Side frame carrier modification to fit victory kit ignition coil

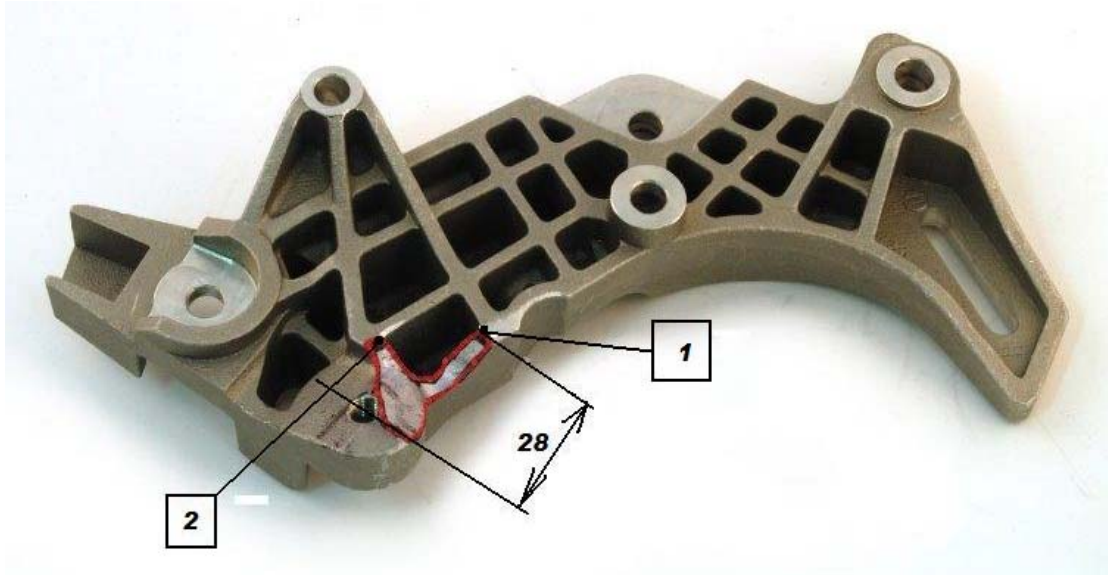
- cut material in 9 mm depth
- width of the cut is 28 mm, make left edge of cut even with thread center
- connect cut with inner edges of ribbing
